SUBJECT: IMPACT OF KINDER MORGAN'S PROPOSED PIPELINE ROUTING PLAN

PURPOSE: To inform Council of the impact of Kinder Morgan's proposed pipeline routing plan and request approval from Council to file formal Statements of Opposition with the National Energy Board.

2.1.1 Staff Comments on Kinder Morgan's Proposed Route Alignment in Burnaby

KINDER MORGAN PIPELINE ROUTE - OVERVIEW MAP

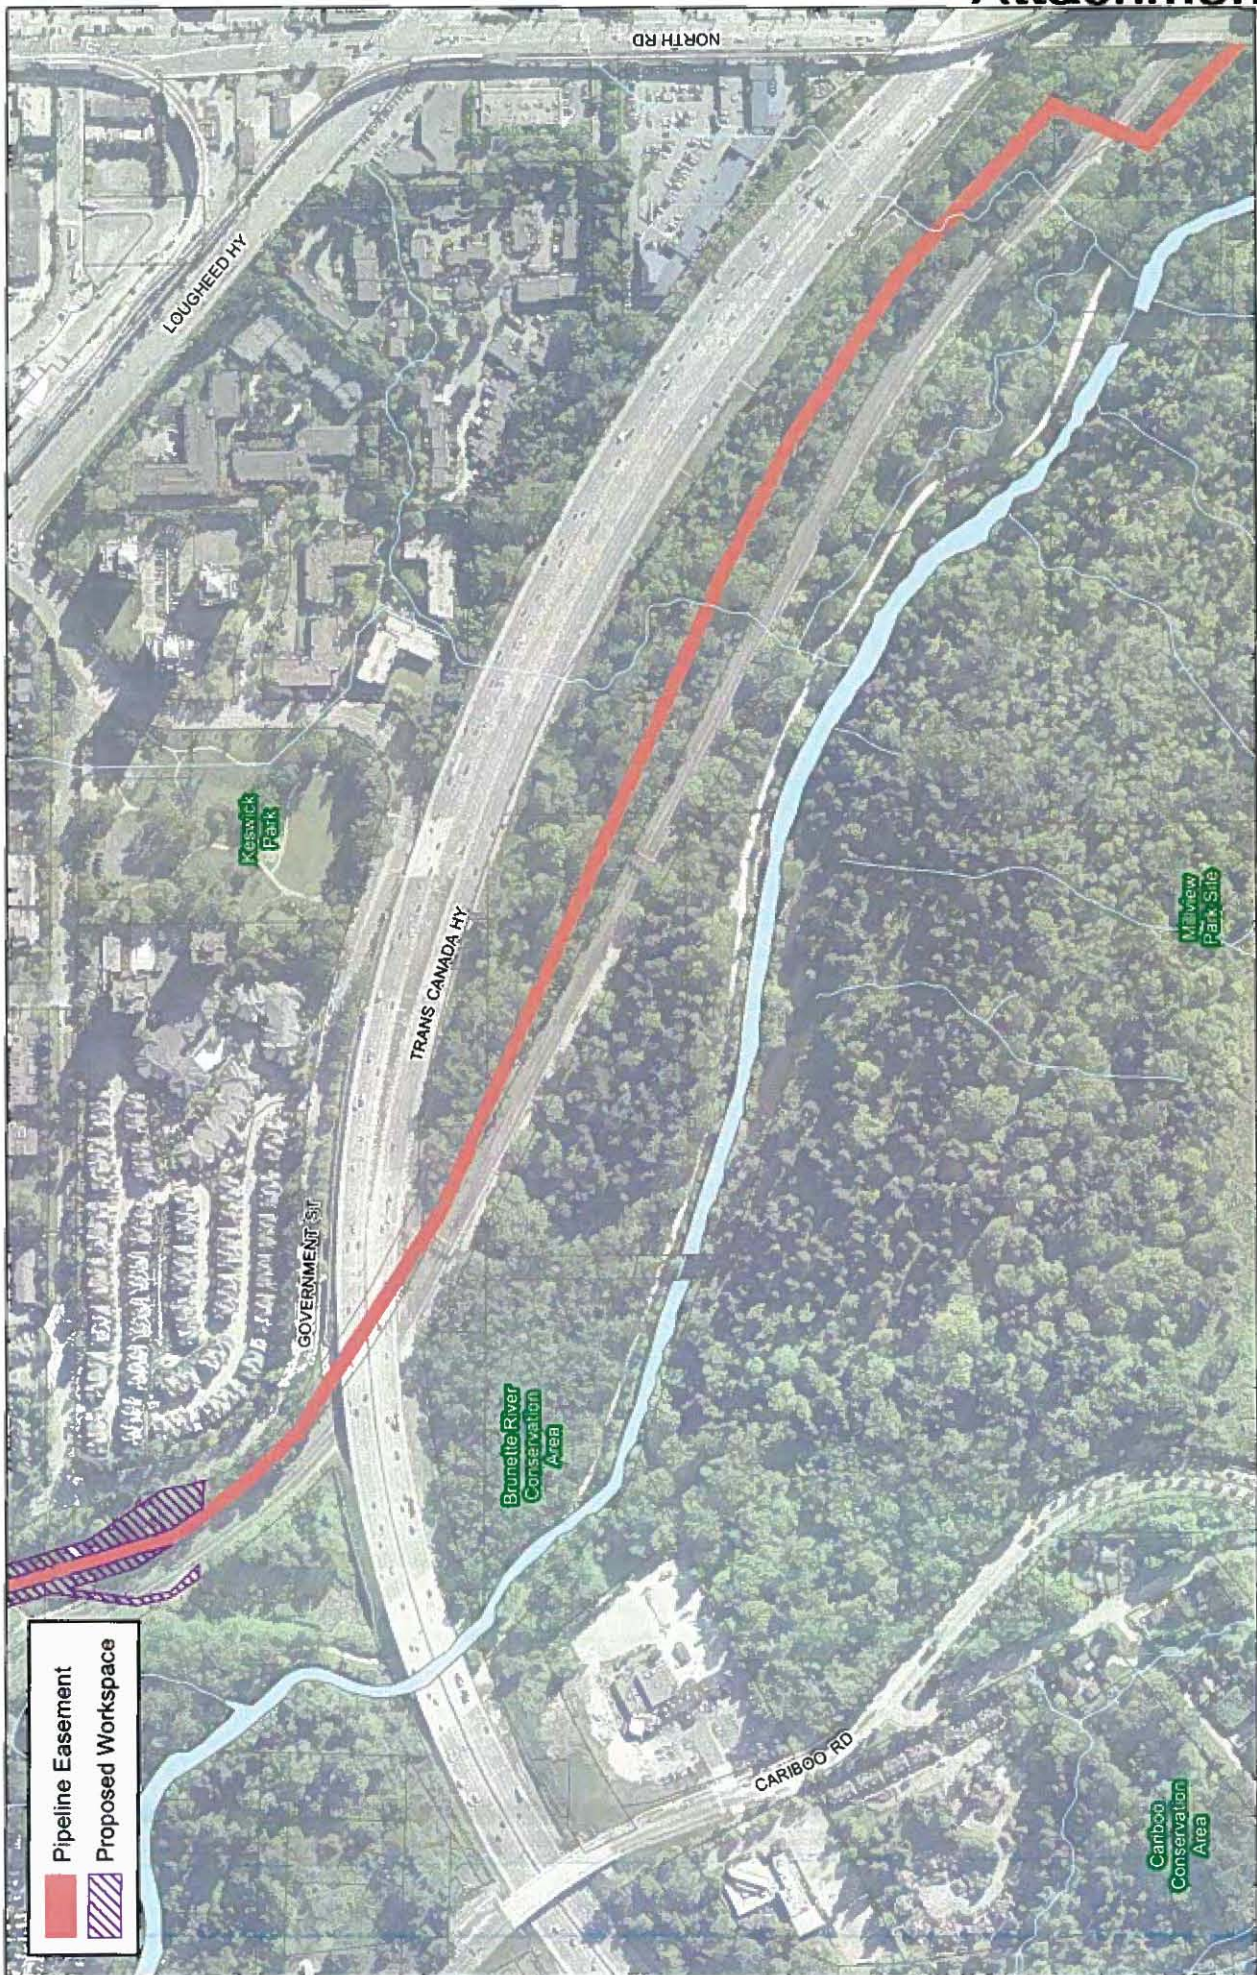
- The entire proposed pipeline route alignment within Burnaby is located in a new corridor (see Attachment #1).
- The NEB Act does not require Kinder Morgan to provide any of the following in the PPBoR:
 - provide or publish workspace and access information beyond the 10-metre wide pipeline easement area;
 - information on work duration within portions of the segment to allow impacted landowners or occupants to assess impacts relating to noise, soils management, access, traffic, dust and lighting;
 - rationale for required workspace area(s);
 - information on timing and mitigation of impacted workspace areas; or
 - information, where applicable, on use of highway and/or local roads as workspace areas which could impact traffic and access.
- Kinder Morgan has not issued notices to owners of Highways and local roads where the proposed detailed route crosses those lands.

Cottonwood Park: Constraint Zones limiting the siting of neighbourhood park facilities and amenities.

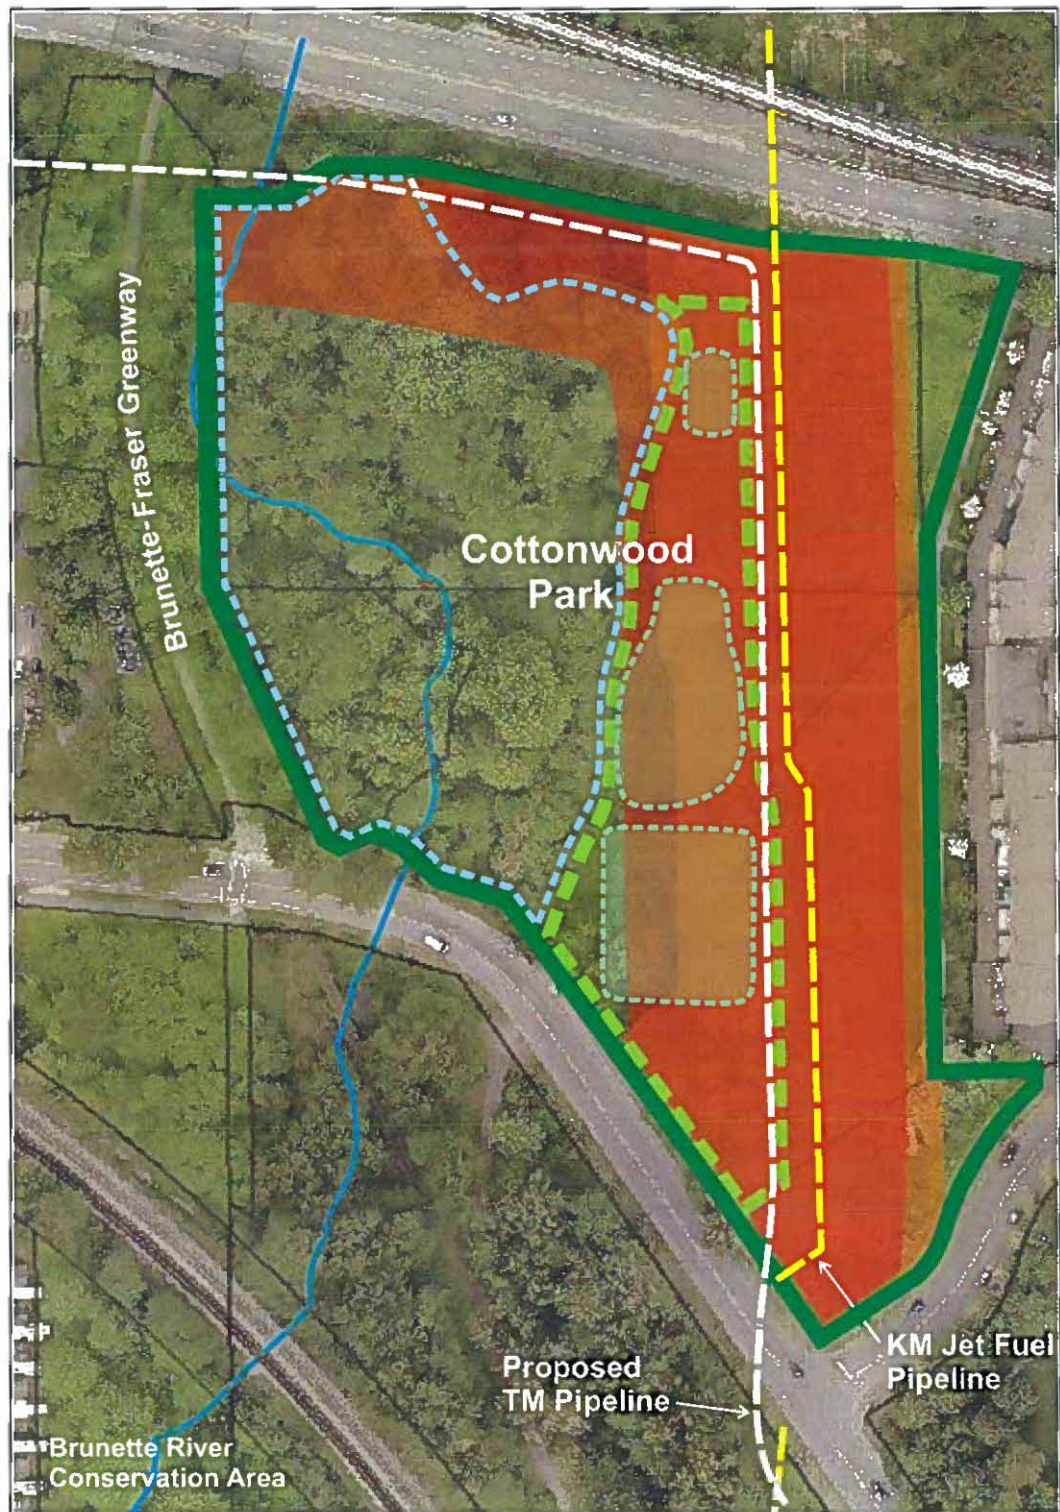
The segment of the alignment to the north leads to Cottonwood Park. Cottonwood Park is to be developed as a neighbourhood park site to serve the residents of the southwest Cameron neighbourhood. Assembly of the site was completed in 2005 with the acquisition of the property, 8839 Government Road, which is located in the core of the park. In addition, the park site contains environmentally significant areas associated with Stoney Creek and its related riparian setbacks to the west of the property. The site also contains the existing Kinder Morgan jet fuel pipeline and BC Hydro power lines to the east of the park property. The proposed new 10.0-metre-wide pipeline easement and the workspace width of 8.0 metres will impose further constraints on the park site and require removal of a significant number of trees and vegetation. In addition, the permanent 10.0-metre-wide footprint of the pipeline easement area will significantly reduce the active usable park zone and sterilize the site in terms for its intended public use (see Attachment #4).
